Access Compliance Report

Public Rights-of-Way

Intersection ID: 1001312	Main Street: FOGGY_MEADOW_RD	Cross Street: N/A	Location: E
ADA ID: B4E76FA8A471	Ramp Type: Para	Initial Pass/Fail: Pass	Overall Compliance: No
		Severity Score: 0.25

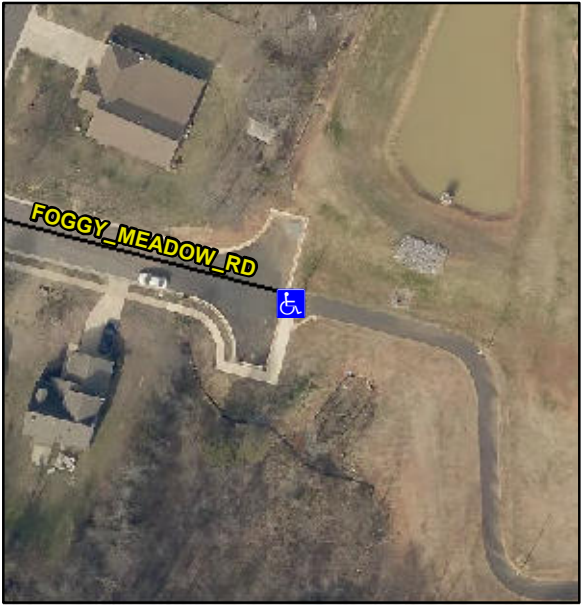
Codes/Mitigation Info/Possible Solution			Field Measurements/Component Compliance		
	Possible Solutions:		Compliance	Description	Data
	Remove & Replace Entire Ramp.		Compliance	Description	Data
			N/A	Ramp Length LT (in)	N/A
			N/A	Ramp Width LT (in)	N/A
			N/A	Ramp Slope LT (%)	N/A
			N/A	Ramp XSlope LT (%)	N/A
			Yes	Landing Length (in)	71.0
			Yes	Landing Width (in)	118.5
			Yes	Landing Slope (%)	1.5
			No	Landing X Slope (%)	2.2
<p>Surveyor Notes:</p> <p>N/A</p> <p>PROW/ADA:</p> <p>R304.5.3</p>			Yes	Landing Curb? (Y/N)	No
			N/A	Shared Landing?	No
			Yes	Gutter Ponding?	No
			Yes	Gutter Lip Ht (in)	0.0
			N/A	Painted X Walk1?	No
				X Walk 1 Direction	To W
			N/A	X Walk 1 Width (in)	N/A
				X Walk 1 Slope (%)	0.4
				X Walk 1 X Slope (%)	1.7
			N/A	Ramp inside XWalk1?	N/A
<p>Total Cost:</p> <p>\$ 1600.00</p>			N/A	Road Slope (%)	N/A
			N/A	Road X Slope (%)	N/A
			Yes	Any Obstructions?	No
				Obstruction Type

N/A		
			Yes	Surface Condition? (G/P)	Good
			N/A	Curb Slope (%)	9.5
